# Access Compliance Report

## Public Rights-of-Way

### (Pedestrian Signals)

| ADA ID: 7D95EDFC9C43                    | Signal Type: Two Push Buttons-APS | Overall Compliance: No                  | Severity Score: BTN 1:N/A BTN 2: N/A No BTN: N/A |

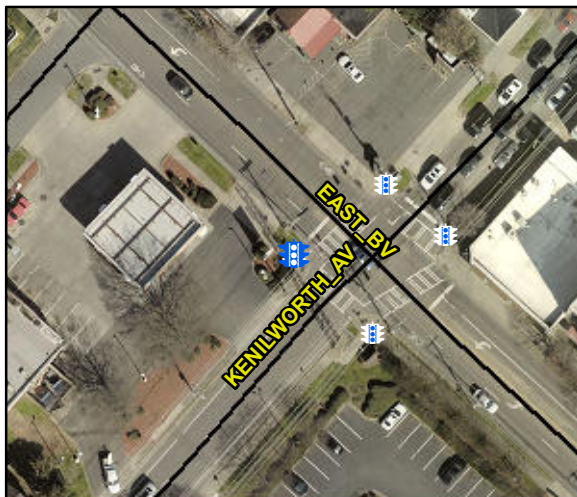
| Compliance | Description                             | Data    | Compliance | Description                            | Data |
|------------|-----------------------------------------|---------|------------|----------------------------------------|------|
| No         | B 1 Sign Lettering & Contrast?          | No      | Yes        | B 2 Sign Lettering & Contrast?         | Yes  |
| No         | B 1 FWD Approach Reach (in)             | 3.0     | No         | B 2 FWD Approach Reach (in)            | 3.0  |

| No  | B 1 DistanceTo Curb (in)  | 78.0          | Yes | B 2 DistanceTo Curb (in)  | 53.0          |

| No                          | B 1 Percussive Walk Cycle?      | Yes                         | B 2 Percussive Walk Cycle?      |

Possible Solutions: Replace Signal Push Button With APS Button on New Post. Remove & Replace Sign. Remove & Replace Replace APS Button With New APS Button.

PROW/ADA: R410.6, TMUTCD 4e.08, R406.2,
